CITY OF ALBUQUERQUE

Re: Miller Bonded Addition, 4420 McLeod Road NE
Permanent Certificate of Occupancy – Transportation Development
Architect's Stamp dated 08-18-09 (F17-D028)
Certification dated 04-15-11

Re: Miller Bonded Addition, 4538 McLeod Avenue NE,
Traffic Circulation Layout
Architect's Stamp dated 08-19-09 (F17-D028)

**Re: Miller Bonded Addition, 4538 McLeod Avenue NE,
Traffic Circulation Layout
Engineer's Stamp dated 06-08-09 (F17-D028)**

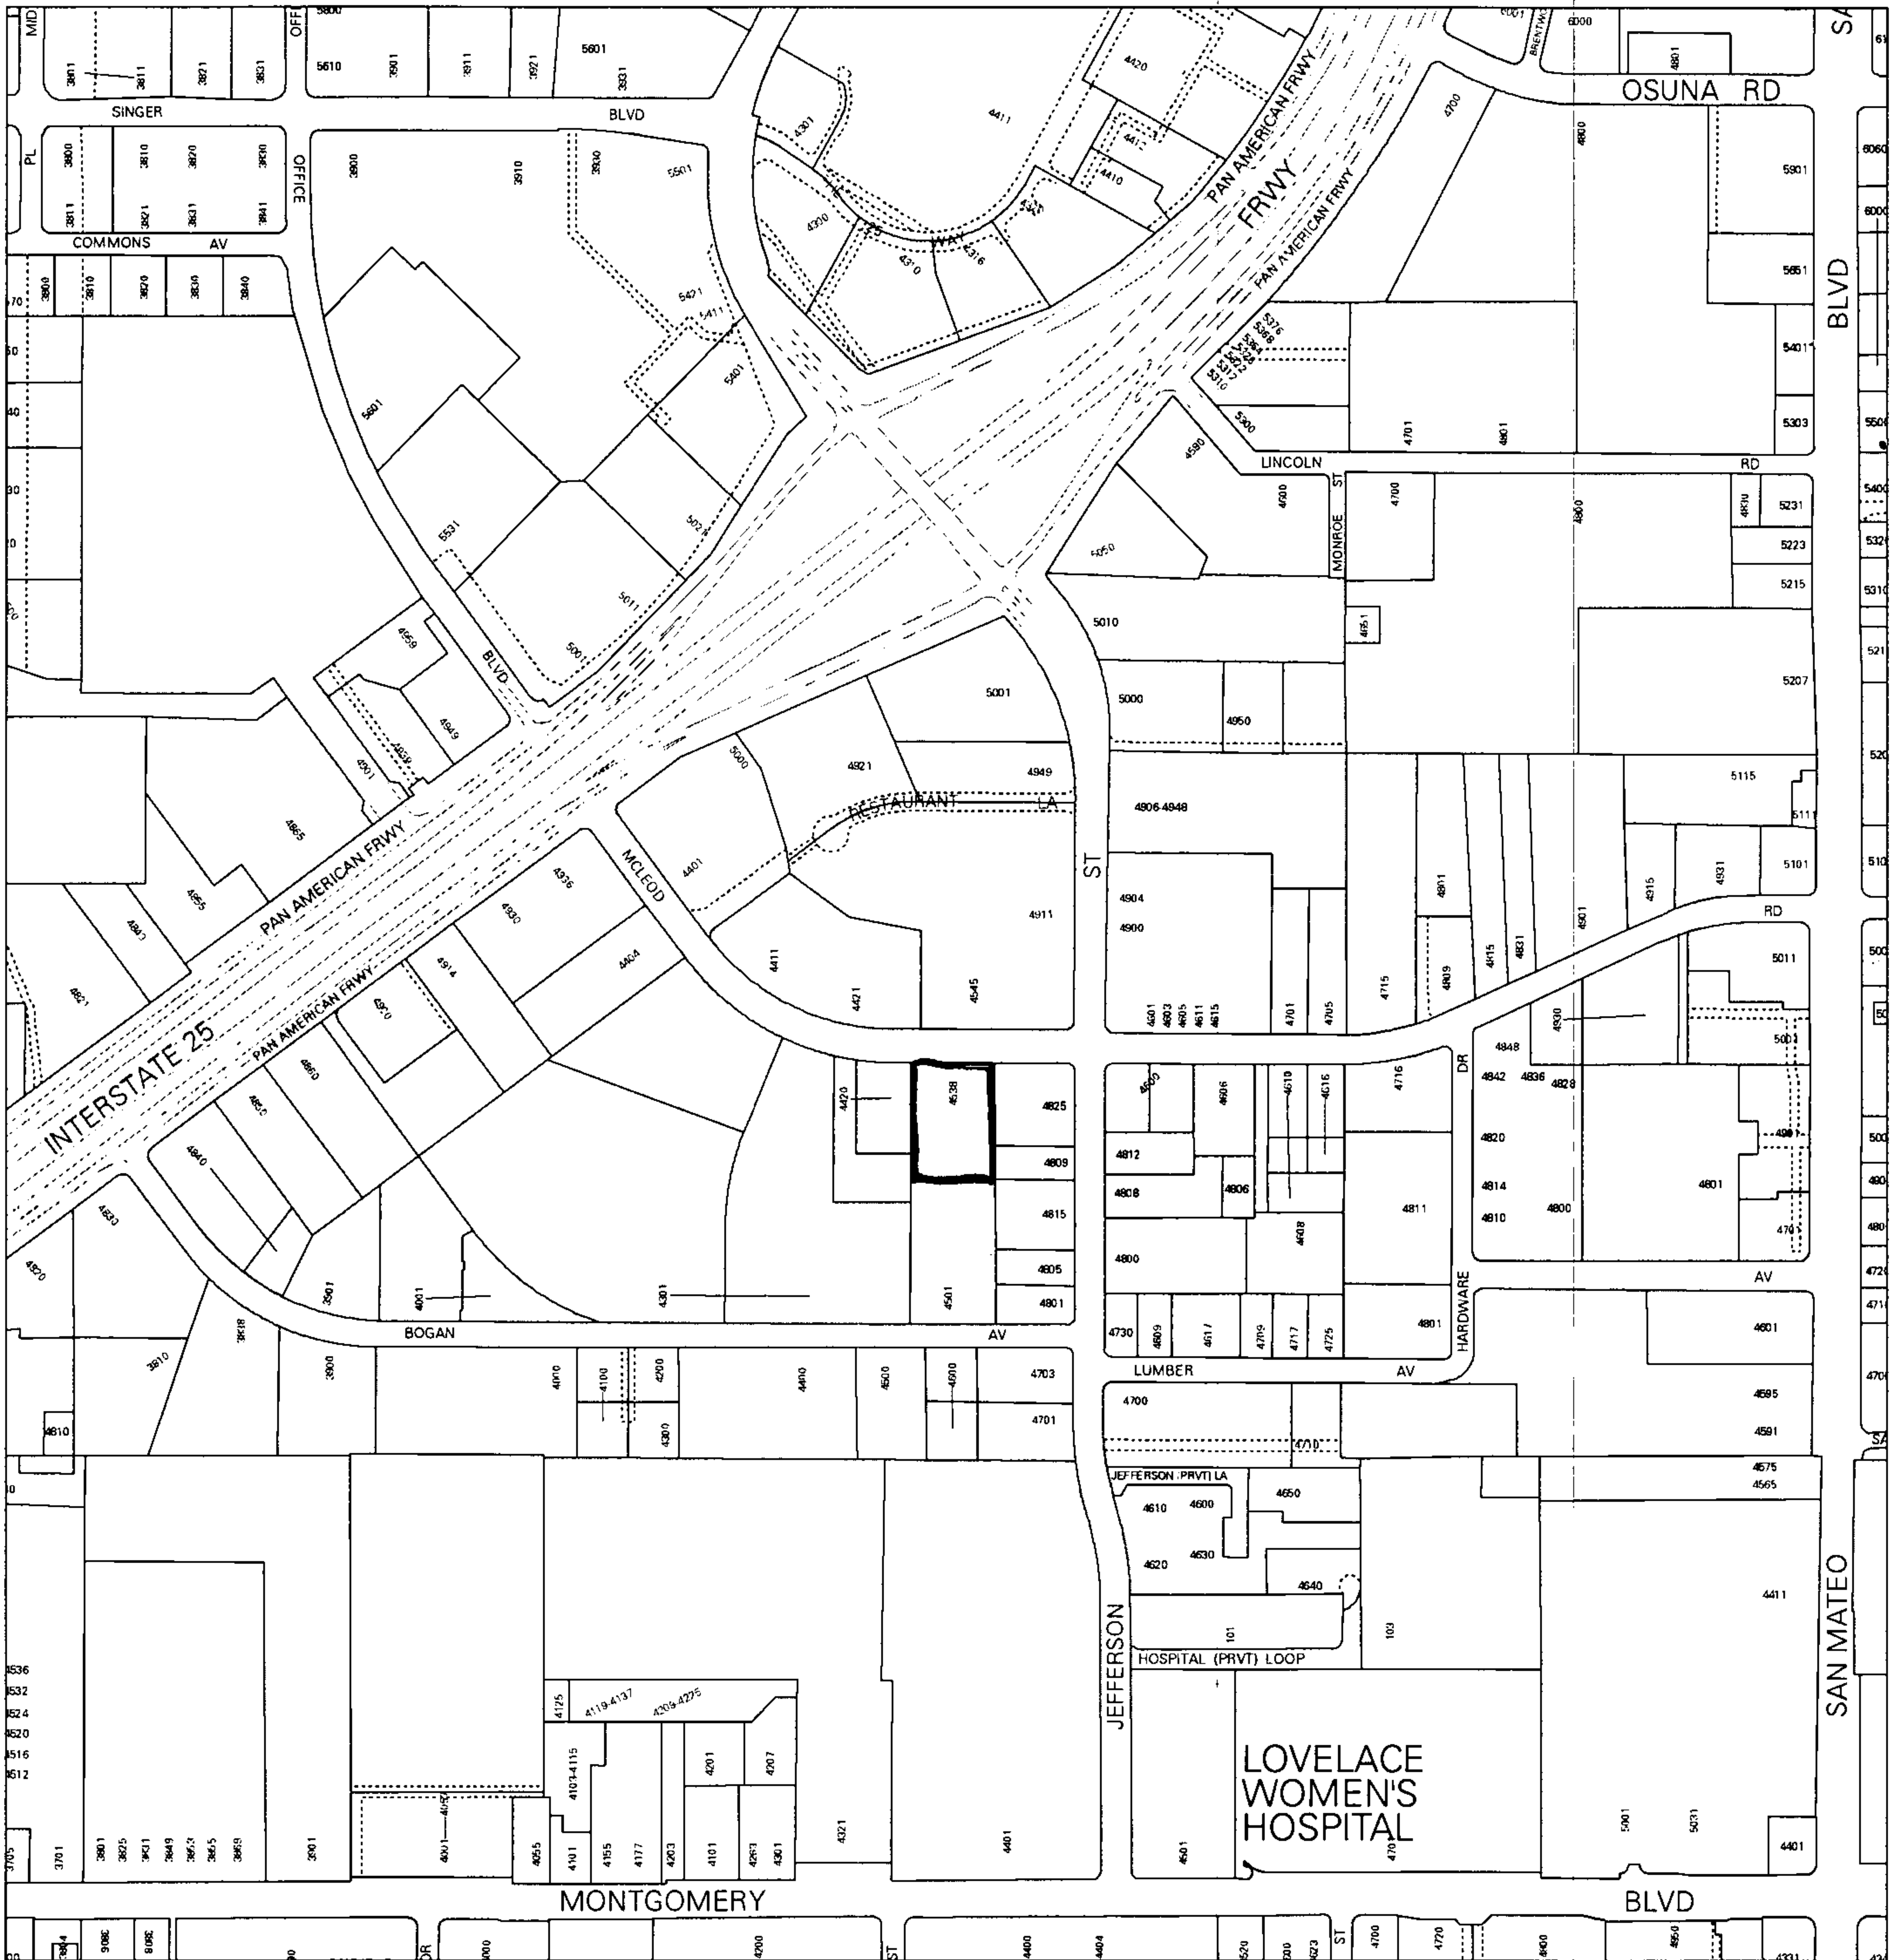
Call out width of all sidewalks, both existing and proposed
Revise keyed note 26 to note 7:12 as the maximum allowable
slope for ramps

Call out the width of the proposed parking spaces along the
western property line

Two-directional traffic must have a minimum aisle width
of 24 feet (see DPM Figure 23.7.1)

A 15' minimum radius is required for passenger vehicles

Provide details for all internal ramps, noting the
maximum slope

Keyed note 18 refers to an enlarged detail. Please provide
a copy of this detail w/ the ~~next~~ next submittal

A 6' wide, ADA accessible pedestrian path

- from street to bldg

- from HC spaces to bldg - need ramps, if req.

Provide add'l info regarding the existing parking lot.

Define the angle of the parking spaces. Two or one Directional?

Proposed SW at R, not back of curb
